# **Comprehensive Review of the Hanford Waste Treatment Plant Flowsheet and Throughput**

**Assessment Conducted by an Independent  
Team of External Experts**

**March 2006**

**Chartered by  
the Hanford Waste Treatment and Immobilization Plant Project  
at the Direction of the US Department of Energy  
Office of Environmental Management  
Washington, DC 20585**

**Figure 2.** Expected WTP Feed Variability [data taken from V. Vora, Dynamic (G2) Model Version 3.1 Verification and Validation Report. 24590-WTP-VV-PO-04-0004, Rev. 0., September 2, 2004]. Circles represent the predicted composition for each WTP feed batch.

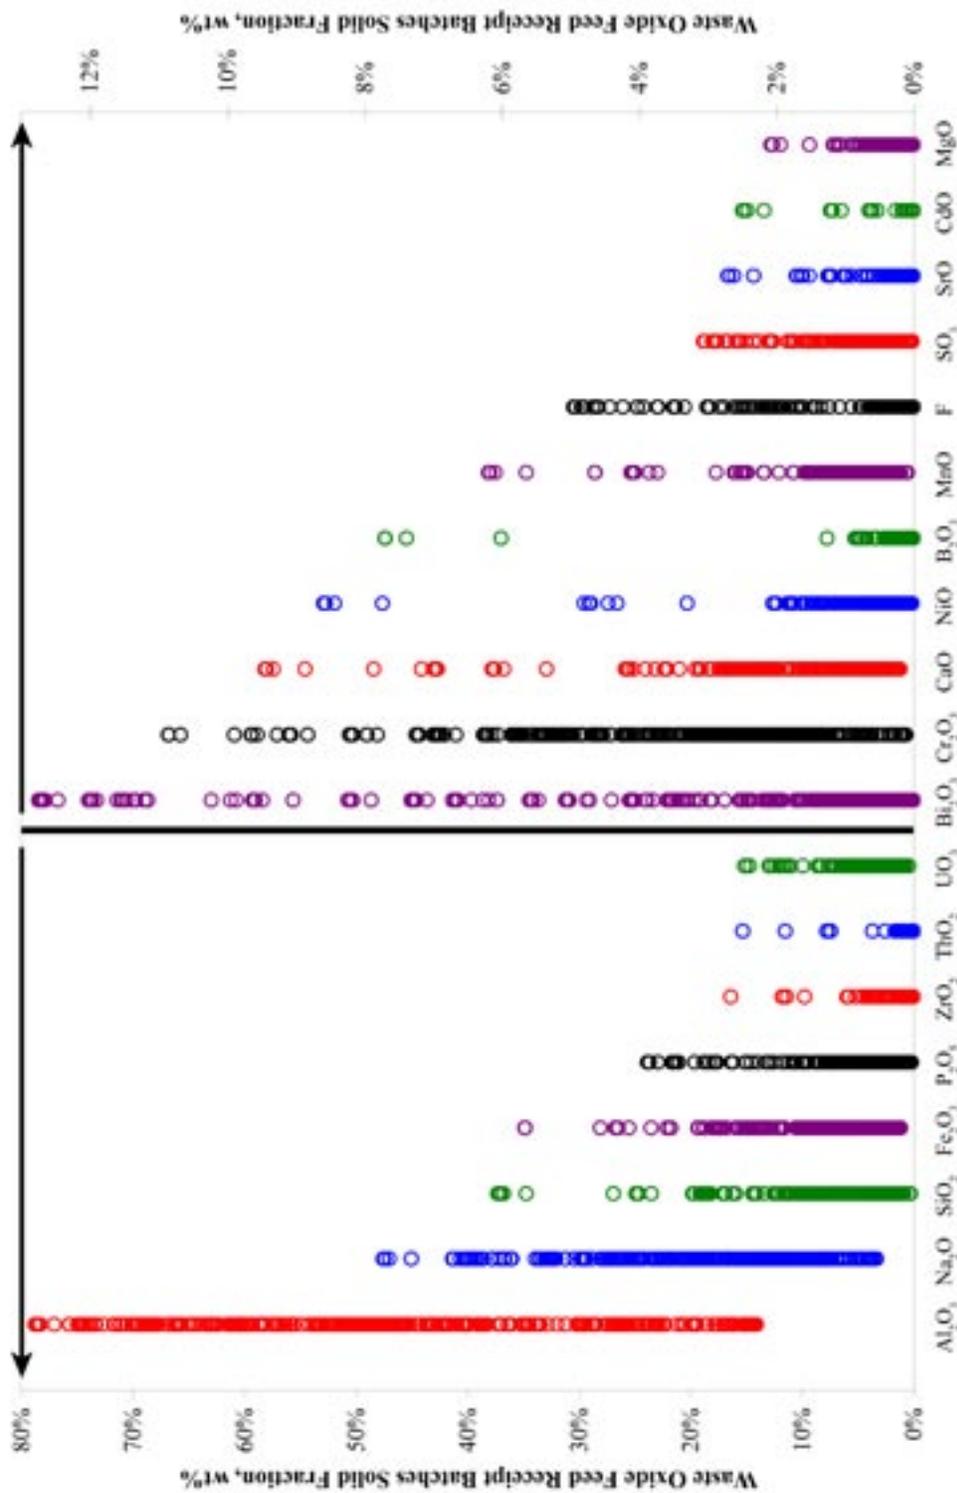
The range of waste compositions (expressed as oxides) currently anticipated to be received by the WTP is shown in Figure 2. Species important to glass performance or processing vary greatly. For example, the aluminum content varies by a factor of 7; the sodium content by a factor of 16. This variability affects equipment design; Plant operations; glass formulations; and, if not designed for, subsequently Plant throughput.

The process flowsheet and Plant design should take the wide range of feed compositions into account. The insoluble waste feed to the WTP will have large fluctuations in the concentrations of iron, aluminum, strontium, sodium, zirconium, and other waste constituents. While the fluctuations for the soluble wastes will be less pronounced, they will also be significant. As a result, the HLW material delivered to the WTP from the tank farms will vary considerably from batch to batch, where “batch” in this context means an approximate 1-million-gallon quantity of waste staged at the tank farms ready to transfer to the WTP.

The WTP must consider the impacts of the feed variability on the Plant’s ability to support the removal of waste from the Hanford tank farms. Even with the feed pre-qualification step recommended by the EFRT, adaptation of glass product control models to include new waste compositions could significantly delay processing. Plugging due to phosphates in soluble wastes has caused serious consequences in the Hanford tank farms and must be addressed before radioactive operations are initiated. An experimental program to resolve

Figure 4. Correlations of UFP Filter Solids Concentration and Permeate Flux Data for WTP (taken from D. Alexander et al., Design Oversight Report, HLW Feed Preparation System; Ultra-Filtration Process System, Figure A.1, D-03-DESIGN-005, DOE ORP, April 2004; BNI CCN 094035, June 6, 2004)

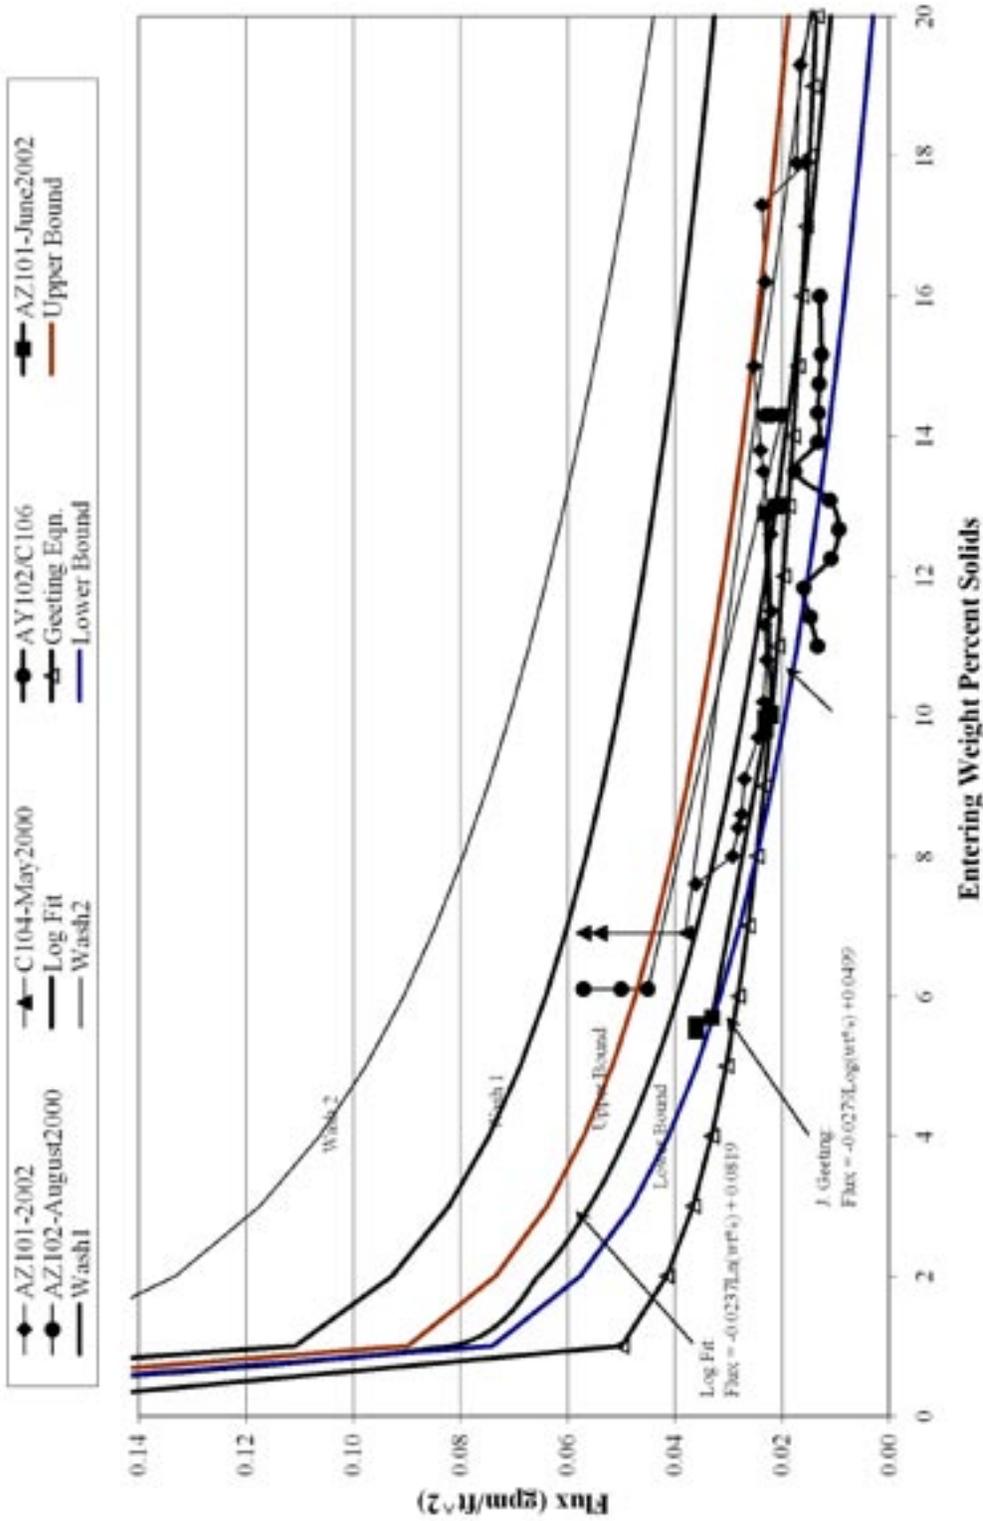
These calculations show that either increasing the filter area by a factor of two or achieving the design flux raises the 100% process capacity to levels that would support the production of 80 MT/day of LAW glass. The actual flux will be known only after the process is operating. It is the EFRT's expectation, based on the data shown in the curve in Figure 4, that the flux will be 0.015 gpm/ft<sup>2</sup>.
